HISTORIC PRESERVATION COMMISSION

Staff Report

CASE NUMBER: HPC11-650
CITATION ISSUED: No
ADDRESS: 624-626 N Bentz Street
APPLICANT NAME: Sue Creamer
PREPARED BY: Lisa Mroszczyk
DATE: November 16, 2011

CASE NUMBER:	HPC11-00652
CITATION ISSUED:	No
ADDRESS:	224 E 7 th Street
OWNER NAME:	Carl Lutz
PREPARED BY:	Christina Martinkosky
DATE:	November 18, 2011

2 NEW SITE PLAN
SCALE: 1"=20'

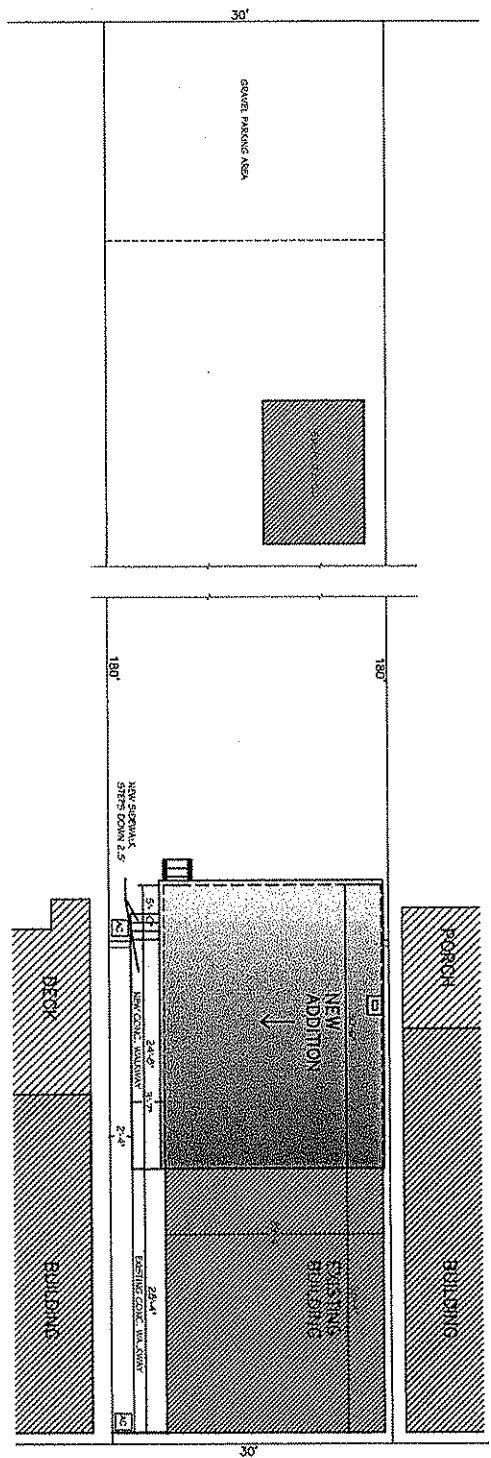
Item 3. As per Section 606 of the Land Management Code, air conditioning units must be placed three (3) feet from the side lot line. The proposed location of the heating/air conditioning unit will need to be relocated.

- As stated earlier, air conditioning units must be placed three (3) feet from the side lot line. The proposed location of both heating/air conditioning units will need to be relocated.
- In regards to overall design Staff has the following comments:
 - Slightly lowering or altering the pitch of the addition roof will distinguish it from the original house. It may create a more interesting design with a hierarchy of building components.
 - The second story rear porch is an appropriate feature that will fit well within the Historic District. However, staff recommends removing the brick detailing between the first and second story. The bricked area above the second story porch could be infilled with wood siding to create a more traditional look.

2 EAST SIDE ELEVATIONS
SCALE: 3/32"=1'-0"

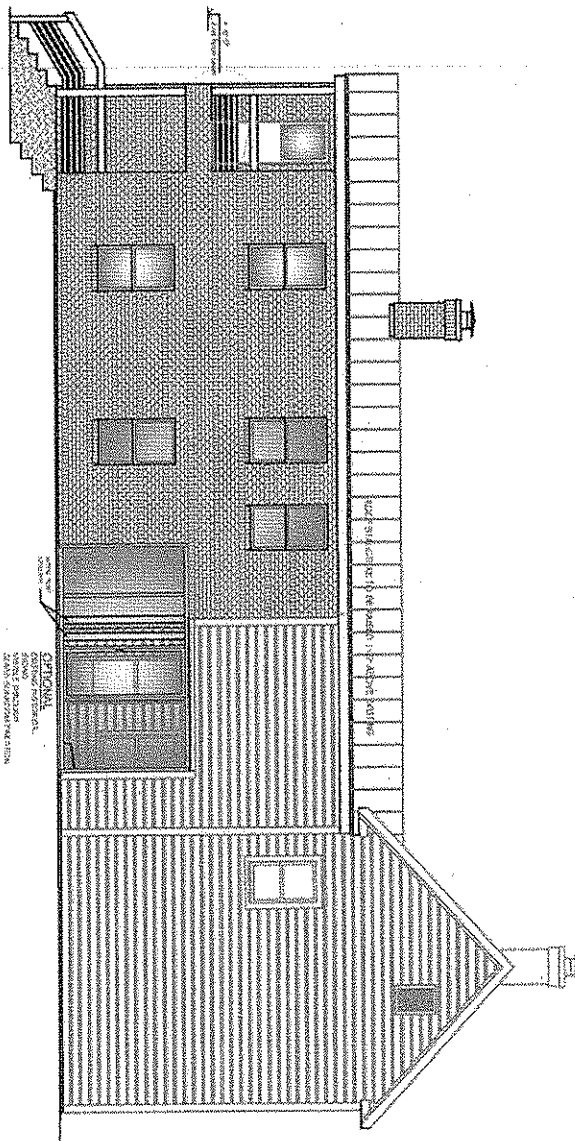
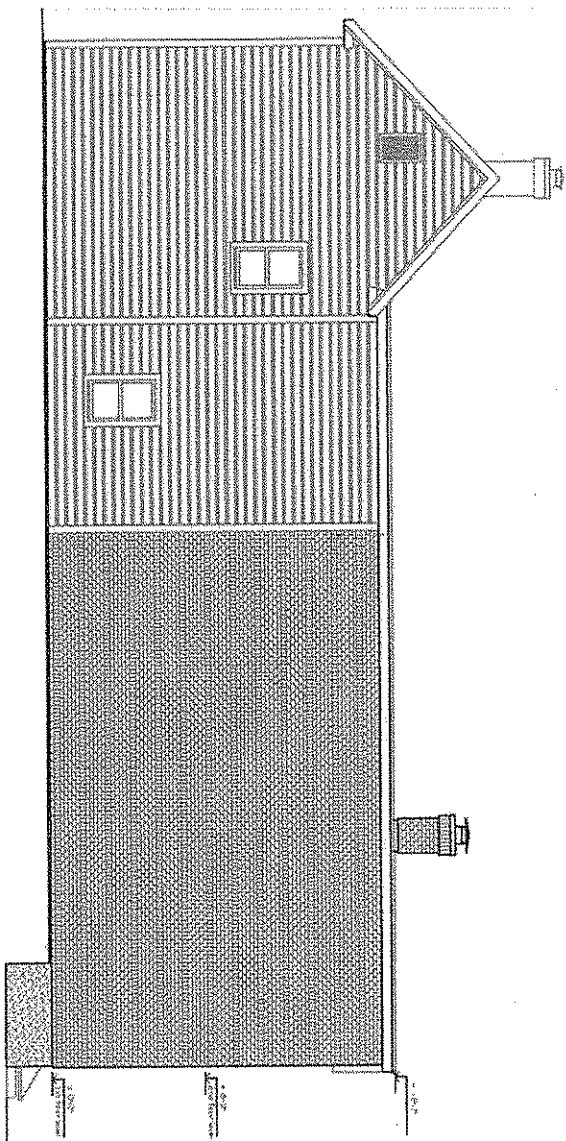
- The majority of the proposed addition features brick walls, however the applicant proposes to enclose the second story of the side porch with German lap siding. Therefore there is no clear delineation between old and new. If the Commission approves infilling the porch, Staff recommends the insertion of a vertical trim element on the second story of the east (side) elevation.

REAR ADDITION ELEVATION

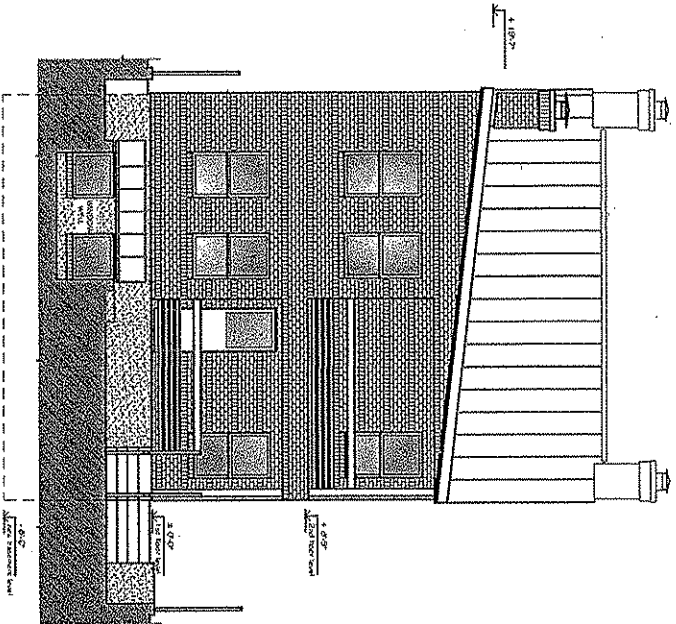
- The applicant proposes to modify the south (rear) elevation of the ell to allow for the new addition. It is important to note that this elevation has already been modified and now features pressed metal siding and 6/6 double-hung wood windows (compared to the German lap siding and 2/2 windows featured on the rest of the building). Staff finds that converting the window openings into doorways may be the most efficient and unobtrusive option to provide access to the new addition, but does have concern creating another opening at the basement level.

- Detailed drawings that will better show the design and materials of the proposed sunroom and the two-story porch on the rear elevation.
- Define the treatment to be applied to exposed foundation on the south (rear) and west (side) elevations.
- Clarify plan for retaining wall in rear yard.
- Catalog cut sheets or other product information for the proposed storm door at the glass sunroom area, wood awning windows located on the south (rear) elevation, and Hardiplank siding.
